# Access Compliance Report

## Public Rights-of-Way

### (Curb Ramps)

Intersection ID: 21533	Main Street: LENOX_POINTE_DR	Cross Street: KINGS_PARADE_BV	Location: N
ADA ID: DEF1F92C10BA	Ramp Type: PerpDiag	Initial Pass/Fail: Fail	Overall Compliance: No
Severity Score: 33.75			
Codes/Mitigation Info/Possible Solution		Field Measurements/Component Compliance

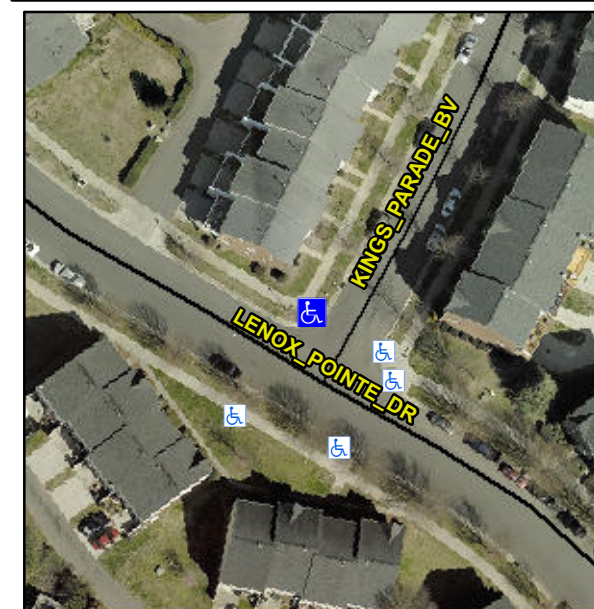
**R304.5.1, R304.2.2, R304.5.3**

Compliance	Description	Data	Compliance	Description	Data
N/A	Ramp Length (in)	46.0	No	Ramp Slope (%)	9.3
No	Ramp Width (in)	46.5	No	Ramp XSlope (%)	6.6
N/A	Flare Type LT	N/A	N/A	Flare Type RT	N/A
N/A	Flare Slope LT (%)	N/A	N/A	Flare Slope RT (%)	N/A
N/A	Flare Traversable LT?	N/A	N/A	Flare Traversable RT?	N/A
N/A	Landing Length (in)	N/A	N/A	DWS Provided?	N/A
N/A	Landing Width (in)	N/A	N/A	DWS Contrast?	N/A
N/A	Landing Slope (%)	N/A	N/A	DWS Length (in)	N/A
N/A	Landing X Slope (%)	N/A	N/A	DWS Full Width?	N/A
N/A	Landing Curb? (Y/N)	N/A	N/A	DWS Offset (in)	N/A
N/A	Shared Landing?	N/A			
N/A	Gutter Ponding?	N/A	N/A	Gutter Slope (%)	N/A
N/A	Gutter Lip Ht (in)	N/A	N/A	Gutter X Slope (%)	N/A
N/A	Painted X Walk1?	No	N/A	Painted X Walk2?	No
	X Walk 1 Direction	To SW		X Walk 2 Direction	To SE
N/A	X Walk 1 Width (in)	N/A	N/A	X Walk 2 Width (in)	N/A
	X Walk 1 Slope (%)	7.9		X Walk 2 Slope (%)	3.4
	X Walk 1 X Slope (%)	1.8		X Walk 2 X Slope (%)	5.6

**Remove & Replace Curb Ramp With Two New Directional Ramps or Equivalent.**
